PEPPER PLACE SUBDIVISION

APPLICATION NUMBER 4 DATE November 15, 2018

DETAIL SITE PLAN

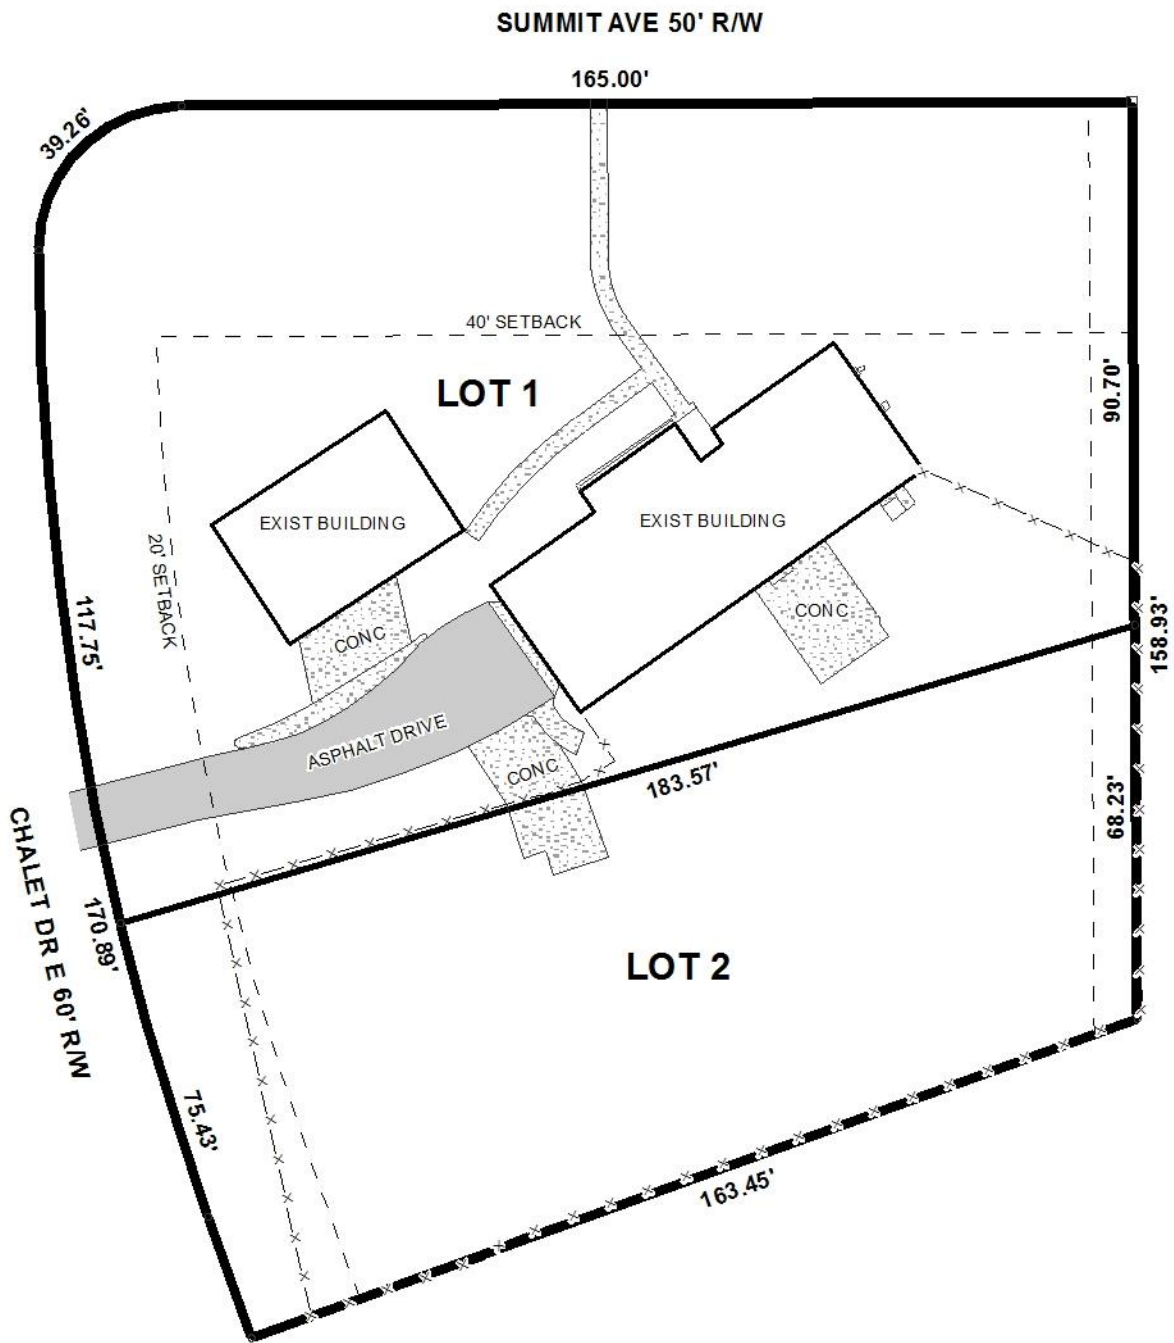
A 40' minimum building setback is illustrated along Summit Avenue, and a 20' minimum building setback line is illustrated along Chalet Drive East, as recorded in Mobile County Probate Court. The minimum building setback line required by Section V.D.9. of the Subdivision Regulations is 25'. While the Planning Commission may have approved a 20' minimum building

setback line along Chalet Drive East, this was done so as a Side Yard Setback line, which is in compliance with the Zoning Ordinance regarding Side Street, Side Yard Setbacks for corner lots. Considering Lot 2 will not be considered a corner lot as a result of the proposed subdivision, the plat should be revised to illustrate a 25' minimum building setback line, but only along the frontage of Lot 2; and the 40' and 20' setbacks for Lot 1 along Summit Avenue and Chalet Drive East, respectively, should be retained on the Final Plat, if approved.

A 7.5' drainage and utility easement was previously recorded along the East property line of the existing lot. This easement also appears to be illustrated along the East property line of both proposed lots, but is not labeled. As such, revision of the plat to label the 7.5' drainage and utility easement should be required, if approved, along with placement of a note on the Final Plat stating no structures shall be placed in any easement.

- 3) revision of the plat to illustrate the 25' minimum building setback line along Lot 2;
- 4) revision of the plat to label the 7.5' drainage and utility easement along the East property line of Lots 1 and 2;

- 5) placement of a note on the Final Plat stating no structures shall be placed in any easement;
- 6) compliance with Engineering comments: (*FINAL PLAT COMMENTS (should be addressed prior to submitting the FINAL PLAT for review and/or signature by the City Engineer): A) Provide all of the required information on the SUBDIVISION PLAT (i.e. signature blocks, signatures, certification statements, written legal description, required notes, legend, scale, bearings and distances) that is required by the current Alabama State Board of Licensure for Professional Engineers and Land Surveyors. B) Provide the Surveyor's, Owner's (notarized), Planning Commission, and Traffic Engineering signatures. C) After addressing all of the FINAL SUBDIVISION PLAT review comments provide the ORIGINAL (with all other signatures) and one (1) copy of the original (signatures not required) of the Final Plat to the Engineering Department.*);
